MIL-C-28748/8E
AMENDMENT 3
12 June 2000
SUPERSEDING
AMENDMENT 2
15 October 1993

MILITARY SPECIFICATION SHEET

CONNECTORS, ELECTRICAL, RECTANGULAR,
RACK AND PANEL, SOLDER TYPE SOCKET CONTACTS, SIZE 22

Insert with 44 contacts

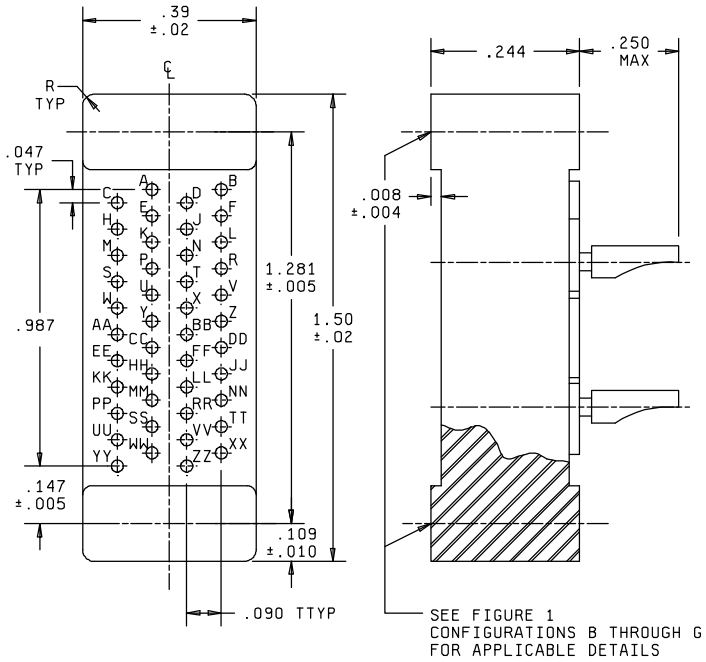
*FIGURE 3, configuration G, delete and substitute as follows:
